SUBJECT: Dam Inspection Report for MEMA #111 – Toddy Pond Dam

#111 Toddy Pond Dam
Town of Orland, Hancock County, ME

Hazard & Condition Report
Date of Inspection – 10/12/2021

Re: Toddy Pond Dam | Orland, Maine

6. Concrete outlet channel. Note close proximity of dam to Hatchery Road & bridge. All concrete serviceable but deteriorated.

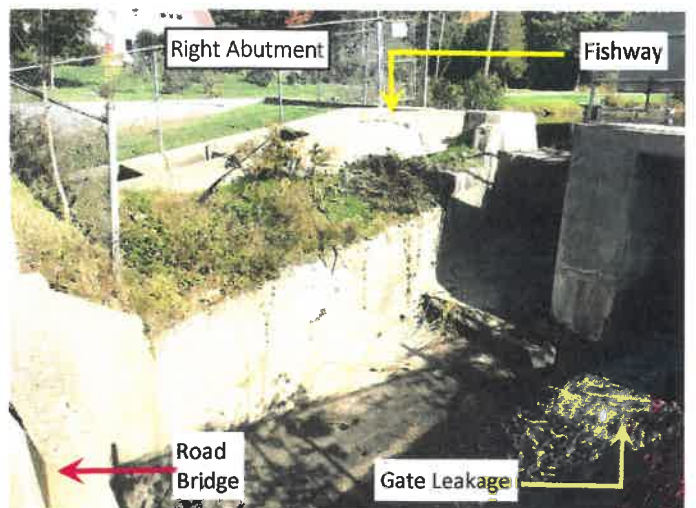
5. Gate opened for inspection. Concrete cutoff wall leads to bridge & gate control. Note fenced channel from spillway to bridge. The lawn is the left embankment.

7. Right uncontrolled spillway. Concrete cracks show seepage but little movement

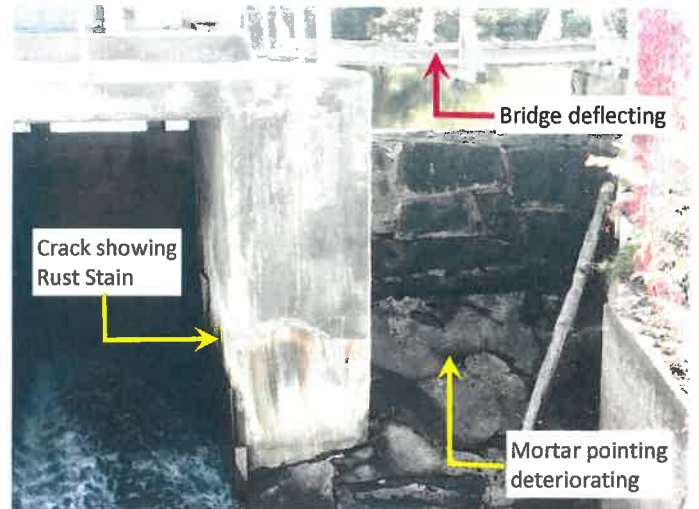
8. Gate & Left uncontrolled spillway. Concrete mortar at gate breaking up. Bridge deflecting. Gate operational.

9. Concrete piers & slab housing sluice gate & electric hoist. Rust streaks are likely at construction joints.

**#111 Toddy Pond Dam
 Dam Breach Inundation Map**

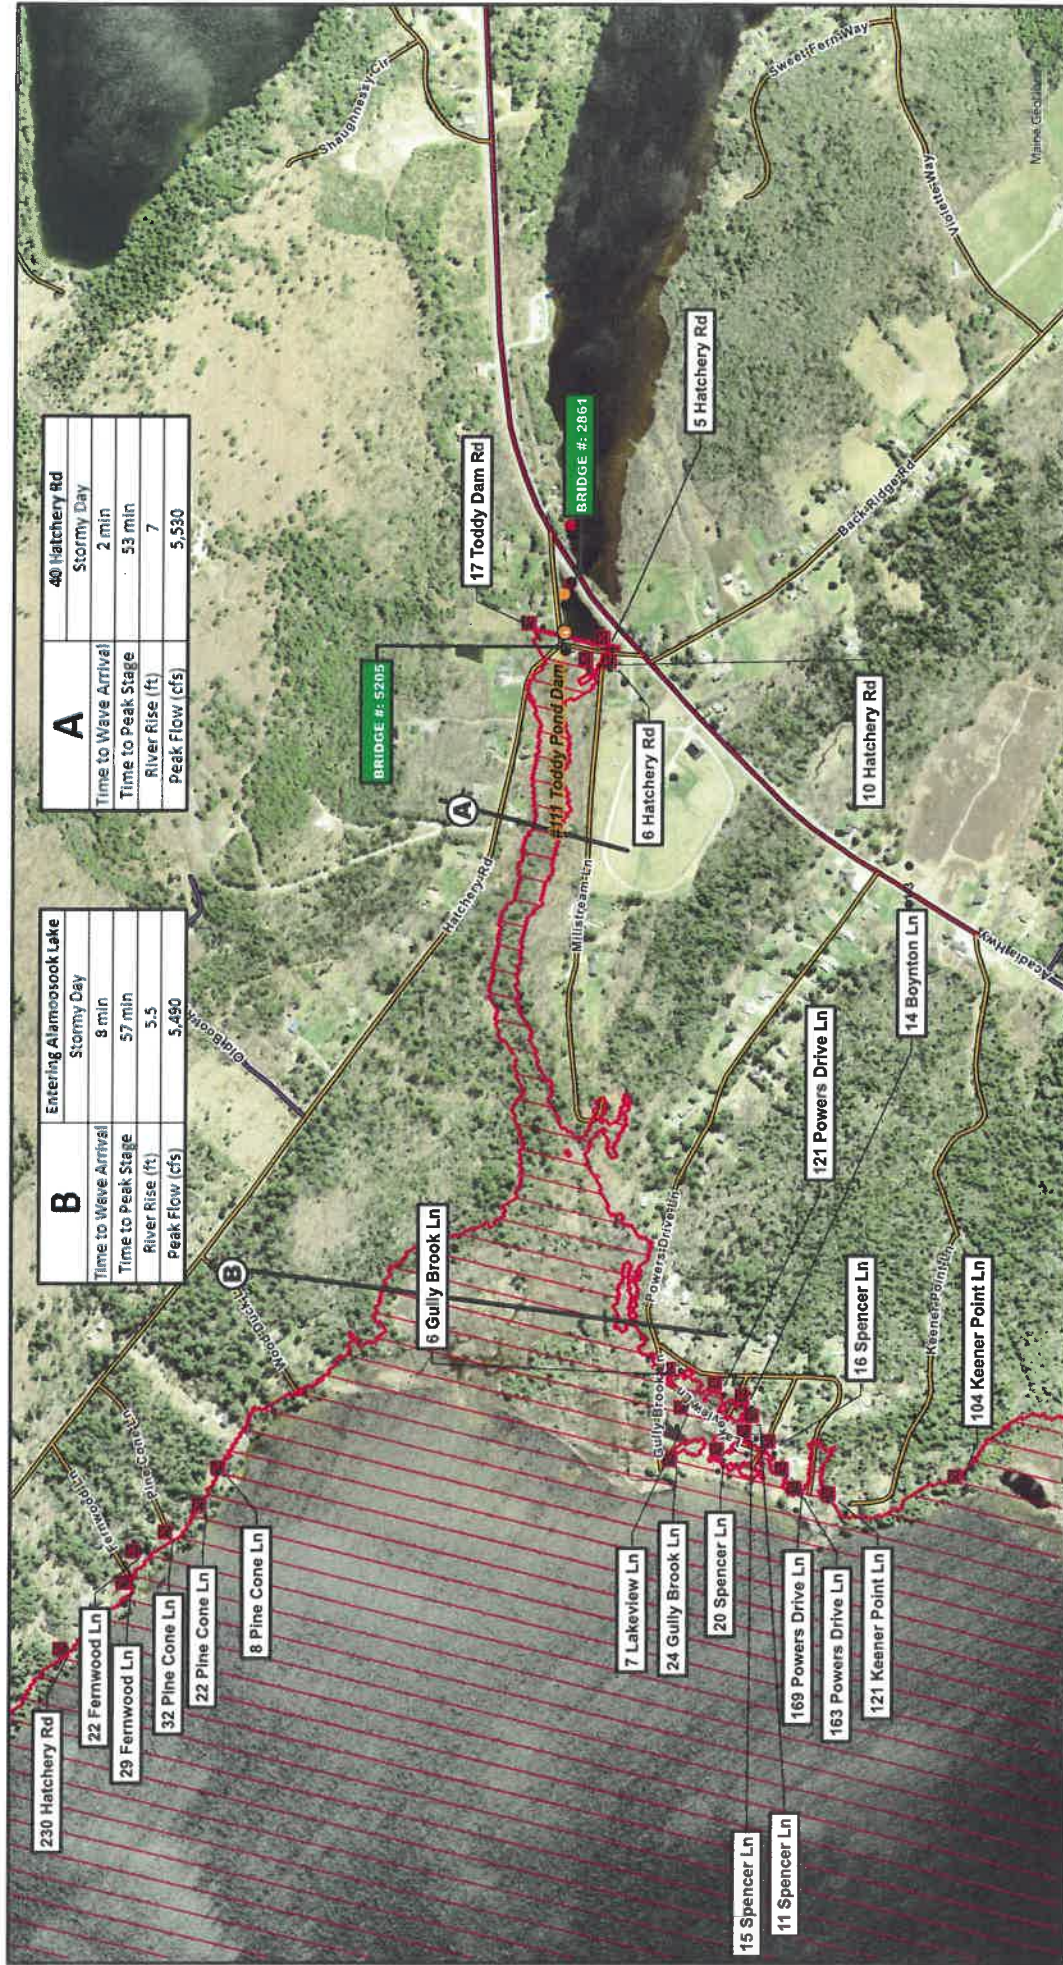
Regarding the dam's Hazard; I have reviewed the dam's emergency action plan (EAP) & the MEMA dam file. The dam's EAP has been tested by the dam owner, however, the current "dam breach inundation map" (DBIM), compared to Attachment F, the DBIM from the MEMA "Toddy Pond Dam Breach Study", 02/07/20, has a considerably smaller dam breach flood line & lacks houses on the left bank of the Narramissic River which are within the Studies breach flood line. The Study map requires confirmation by the dam owner. It is sufficiently accurate to reclassify Toddy Pond Dam a "high" hazard potential dam. One point to note is that if Toddy Pond Dam fails, Alamoosook Lake rises about 3 times the rate Toddy Pond draws down, this is likely to cause shorefront flooding & should be noted by the Town EMA.

Attachment F is a map which shows the course of the Narramissic river downstream from Toddy Pond Dam to Alamoosook Lake. This map has been copied from the dam breach inundation map (DBIM) developed for the MEMA "Toddy Pond Dam Breach Study", 02/07/20. This map shows the entire 3,800' course of the Narramissic River. The map also shows the Toddy Pond Dam breach (5,530 cfs) flood line & downstream infrastructure & houses likely to be flooded. Sections A&B show the breach data. Toddy Pond Dam is 144' higher than Alamoosook Lake, thus the Narramissic river is hydraulically steep (1:26) & discharges from the dam will be fast & turbulent. The breach flow is estimated to exceed 30 mph.

The Toddy Pond Dam EAP is incomplete & requires the following; a new downstream inundation map based on breach criteria assumed in this report. Further, the EAP must include a list of all houses & infrastructure impacted by the dam breach, the address of each, the number of house occupants & the house contact name & phone number.
